RESOLUTION NO. 2014-230

A RESOLUTION TO AMEND RESOLUTION NO. 2013-201, AUTHORIZING THE USE OF SECOND GENERATION ENTERPRISE ZONE ASSISTANCE FUNDS FOR THE MAIN STREET FAÇADE IMPROVEMENT PROGRAM FOR VINELAND ELKS LODGE # 1422.

Proposed Change Order for Reconstruction of the Exterior Masonry Wall

Re: Visual Inspection & Assessment Report
Vineland Elks Lodge Renovation (Reliance No. 2 Firehouse)
6th Street, Vineland, New Jersey
HJCG No. 20130.057

Plate 1: Proposed Reconstruction Method at East Elevation

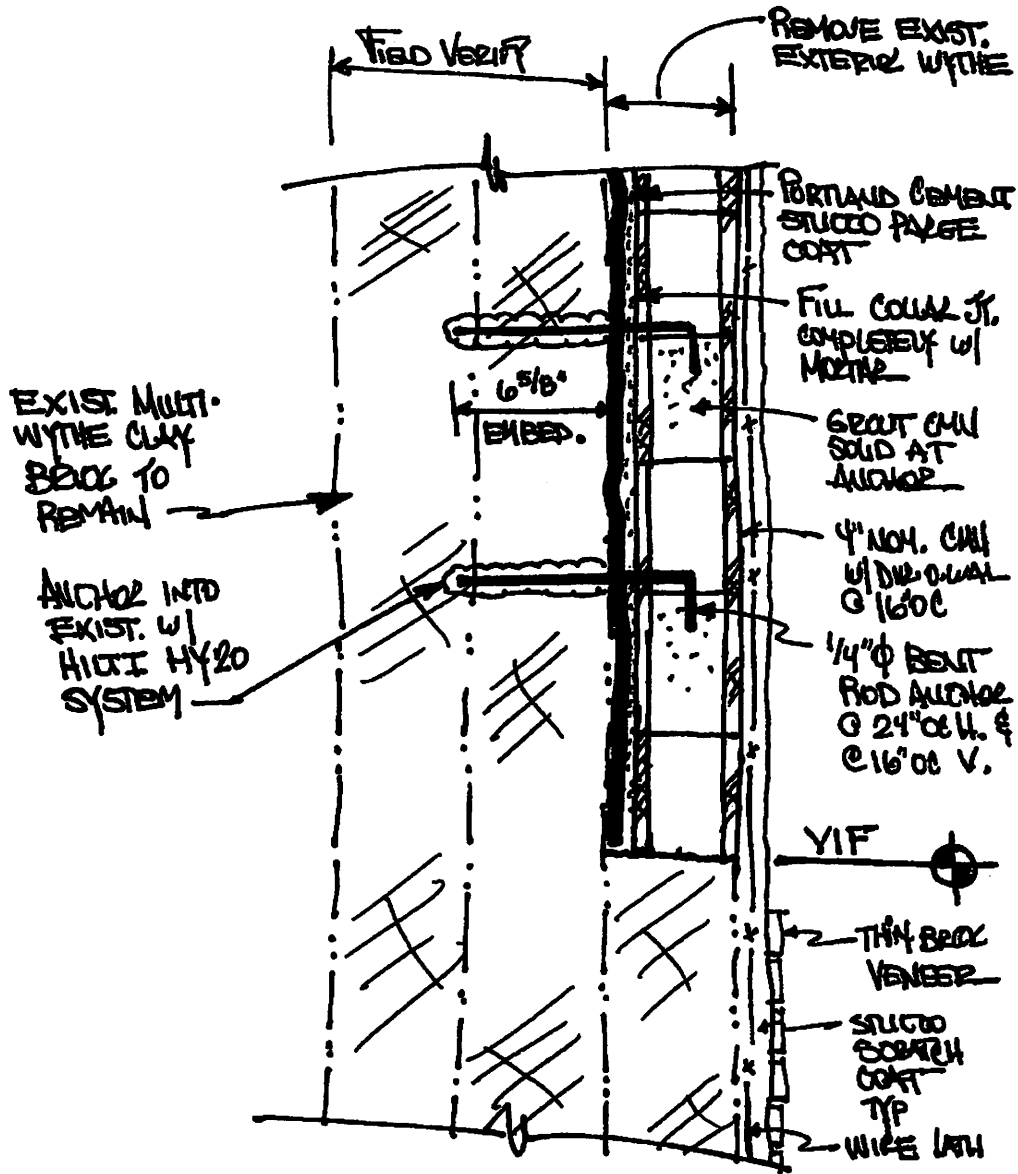
Option #3: Remove loose and deteriorated face brick (top of wall down to mid-height of second floor level)

The exposed red brick back-up wall would receive a parge coat of Portland cement stucco. New 4" nominal CMU masonry units will be mortared into the wall to reconstruct the outer wythe. The new units will be conventional 8"x16" nominal units in lieu of the brick units from the original construction. The new masonry construction will be mechanically anchored into the existing clay brick back-up wall. Please refer to Plate #1 on the following page.

Once the reconstruction is completed, wire latch and the thin brick veneer will be applied to the wall. The original signage will be removed as part of the reconstruction, cleaned, and reset into the reconstructed wall. The original wall copings will be removed, cleaned, and replaced along with new through-wall flashings and appropriate joint sealants.

- Remove the deteriorated face brick to mid-height of the second floor level
- Apply a parge coat of Portland cement stucco to the existing back-up wythe of the exposed wall
- Provide mechanical anchors of the new block work to the existing brick back-up as per the detail developed in the report
- Provide new 8" x 16" masonry block in place of the removed brick
- Remove the existing cast letters of the building, clean and reset into the reconstructed wall
- The original coping will be removed, cleaned and replaced along with new through-wall flashing and joint sealants
